# UNITED STATES PATENT AND TRADEMARK OFFICE

| APPLICATION NO.  | FILING DATE | FIRST NAMED INVENTOR | ATTORNEY DOCKET NO.             | CONFIRMATION NO. |
|--|-------------|----------------------|---------------------------------|------------------|
| 10/809,336   | 03/26/2004  | Cecilia DeVenezia    | DV-04                           | 9525             |

| <b>Office Action Summary</b> | <b>Application No.</b><br>10/809,336 | <b>Applicant(s)</b><br>DEVENEZIA ET AL. |  |

## DETAILED ACTION

Jacinto et al. Figure 1

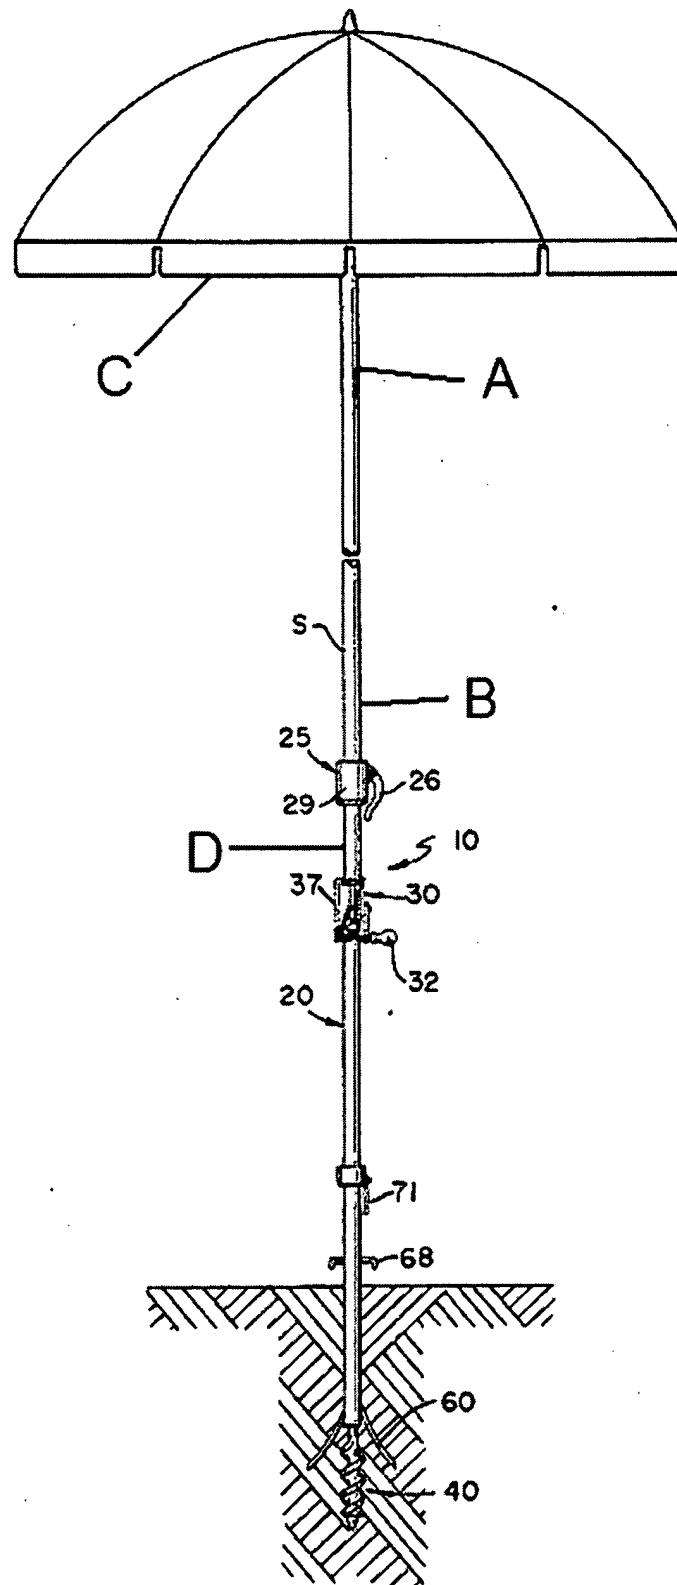
9. Claim 1 is rejected under 35 U.S.C. 103(a) as being unpatentable over Jacinto et al. in US Patent 5152495 in view of Doreste in US Patent 6267127. Jacinto et al. disclose a self-anchoring beach umbrella comprising a canopy member having an upper tubular element (A), to which a spreadable canopy (C) is attached, and a lower tubular element (B); a pole member (20) having an upper element (D), a motor element (137), comprising a reversible electric motor (80), having on its lower end an axially-disposed shaft (35) through which a rotary torque is generated when the motor is activated and an auger (40) coupled to the shaft of the reversible electric motor such that the auger

rotates in a forward or reverse direction when the motor is activated; a battery chamber (E) located in or mounted upon the pole member, said battery chamber having within it one or more batteries (90) and having a means (F) for accessing said batteries so that they may be removed and replaced or recharged; a switch (100) mounted on the motor element of the pole member and electrically connected to the batteries, whereby the motor may be activated and the direction and speed of the motor may be controlled.

Campomar, Figure 3

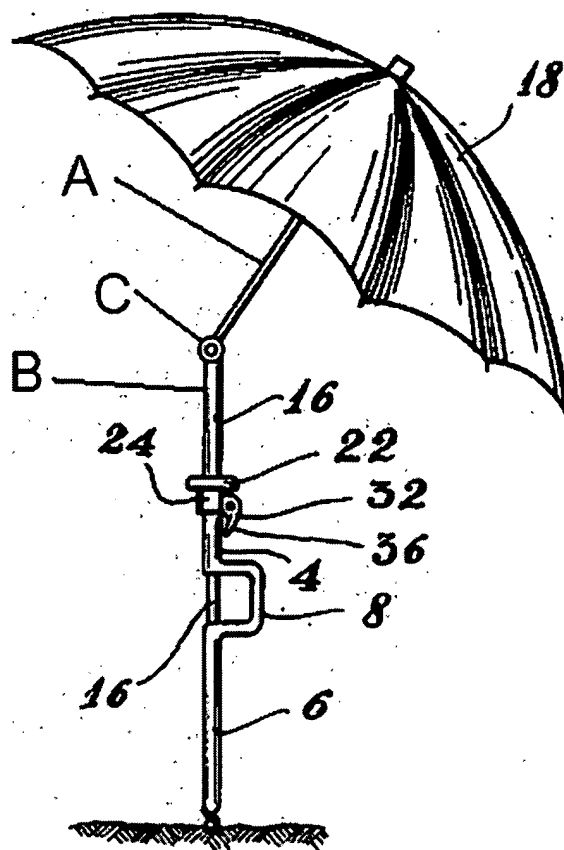
15. Claim 7 is rejected under 35 U.S.C. 103(a) as being unpatentable over Jacinto et al. in view of Doreste as applied to claim 1 above, and further in view of Campomar in US Patent 2628797. As stated above, Jacinto et al. in view of Doreste teaches all of the limitations of Claim 1 including an augur-anchored beach umbrella, but does not teach a tilting umbrella. Campomar teaches an auger-anchored umbrella with a joint means (C) disposed between the upper (A) and lower (B) tubular elements for tilting the upper tubular element of the canopy about an axis with respect to the lower tubular element. It would have been obvious to one of ordinary skill in the art at the time of invention to modify the device of Jacinto et al. in view of Doreste by using a tilting umbrella as taught by Campomar in order to change the position of the umbrella without changing the anchor position.
